WORK INSPECTION REQUEST (WIR) FORM

Contractor:	HAIF-FREYSSINET JV
Project:	RA2RC
Contract No.:	QPMO-410-CT-00618
Work Inspection Request Number:	QRXM114000-HFC-TEC-WIR-ITS-02-RO5-00099

Inspection request for Installation of CCTV pole 15mtrs, Junction#1 , 01 pole, Junction#2 , 01 pole and Junction#3 , 01 pole, Total 03 poles, at Access to Resort core interim Road. As per attached drawing.

Project Name: Package 3 - **Interim Road Access to Resort Core**	**Project Code:** QRXM114000
Location: 00	**Date:** 22-January-2026
Document Title: **Material Approval Request FOR ITS SYSTEM SUPPLYING & INSTALLING BY TRAFFIC TECH SECURITY W.L.L (**ITS and CCTV Poles**)**	**Ref No:** QRXM114000-HFC-TEC-MAT-ITS-02-RO5-00017
	Rev No: 00

Drawing title:
SHOPDRAWING OF TRAFFIC SIGNAL SYSTEM FOR JUNCTION-1

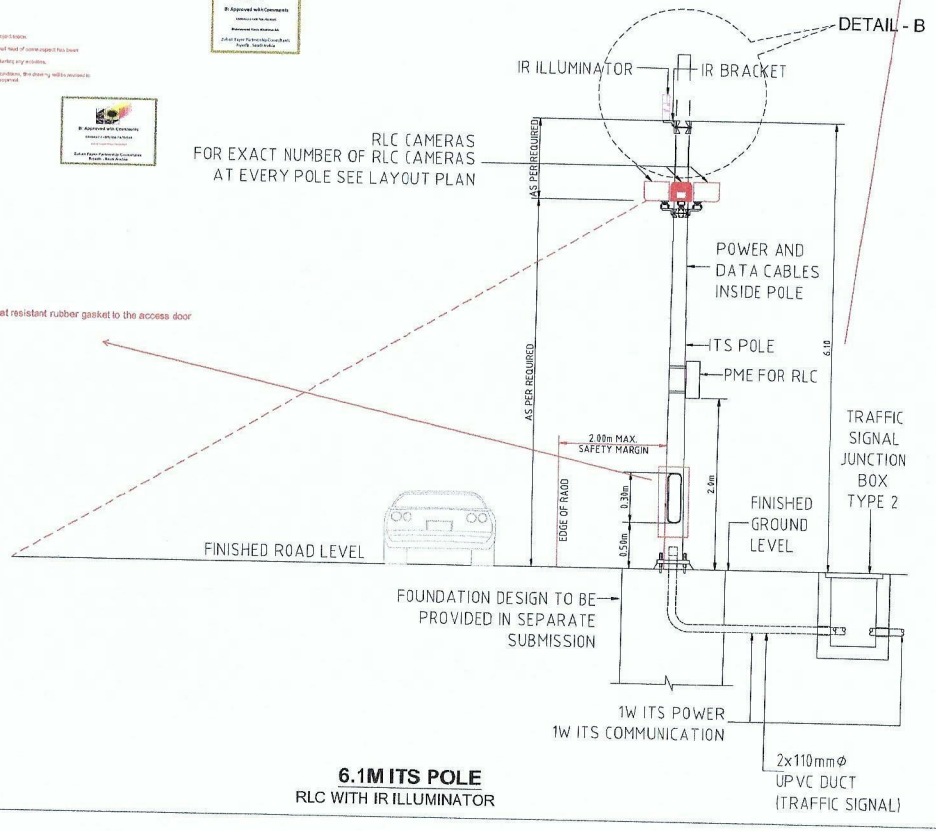
Devices mounting height shall be as per the manufacturer's recommendation and site conditions to achieve optimal performance

Provide non-degradable heat resistant rubber gasket to the access door

Drawing title:
SHOPDRAWING OF TRAFFIC SIGNAL SYSTEM FOR JUNCTION-2
TYPICAL STANDARD DETAIL OF ITS POLE CCTV & RLC WITH IR ILLUMINATOR

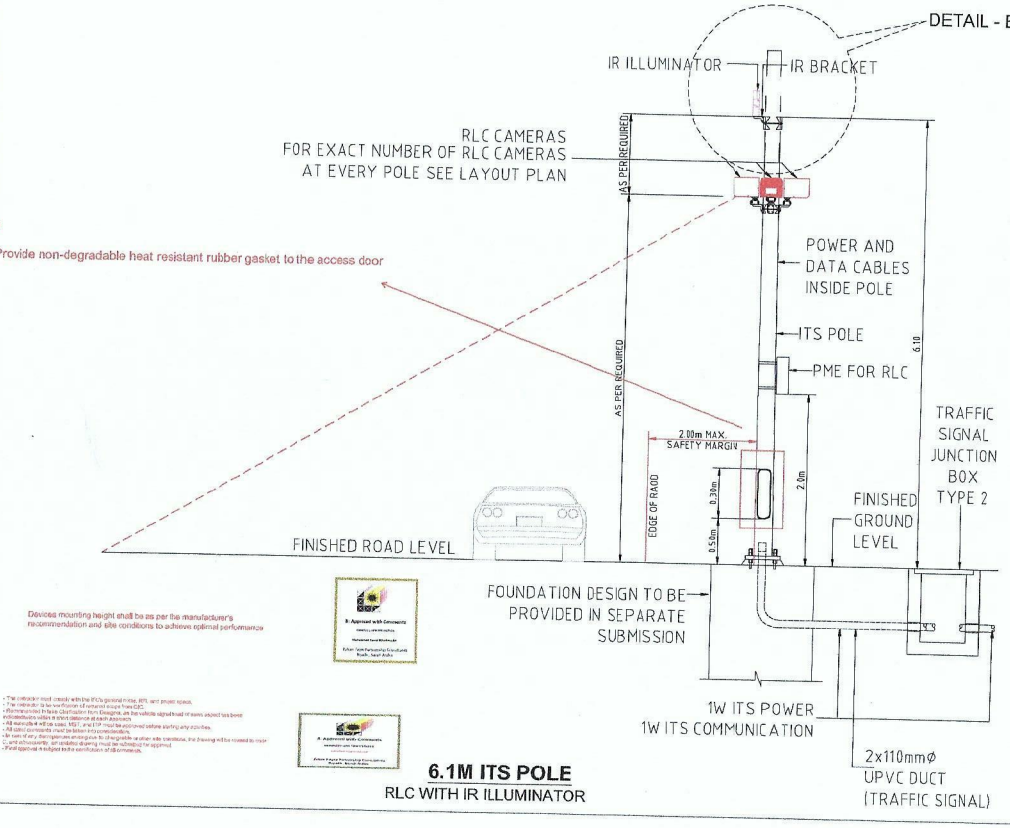
Devices mounting height shall be as per the manufacturer's recommendation and site conditions to achieve optimal performance

Drawing title:
SHOPDRAWING OF TRAFFIC SIGNAL SYSTEM FOR JUNCTION-3
TYPICAL STANDARD DETAIL OF ITS POLE CCTV & RLC WITH IR ILLUMINATOR

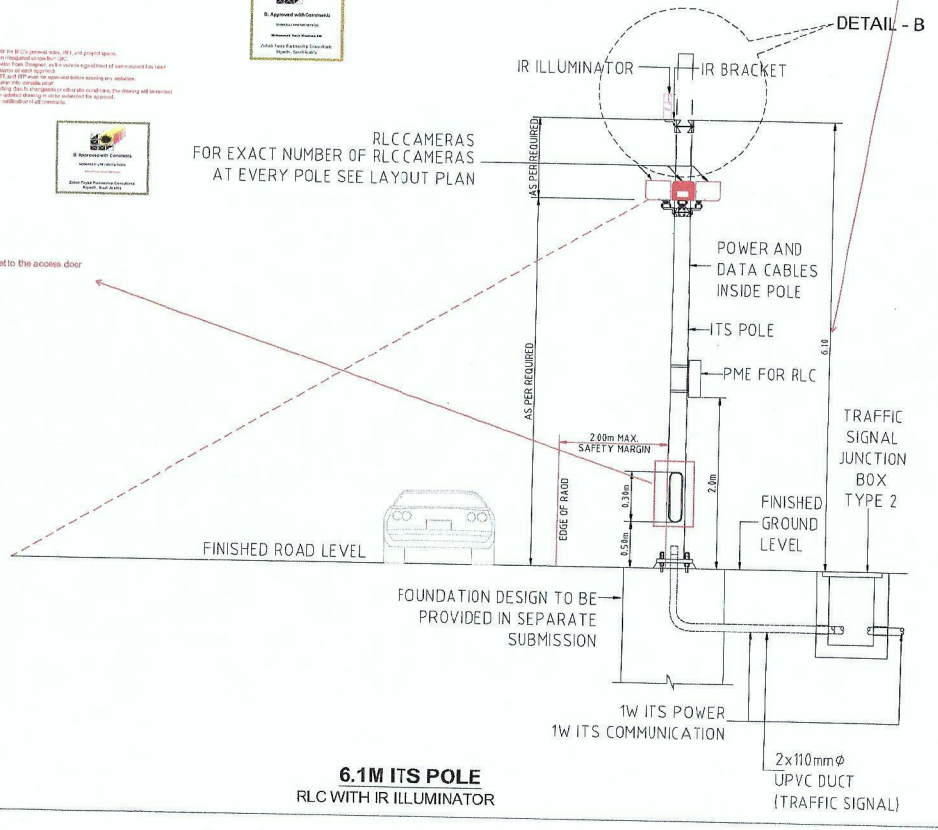
Devices mounting height shall be as per the manufacturer's recommendation and site conditions to achieve optimal performance

Provide non-degradable heat resistant rubber gasket to the access door
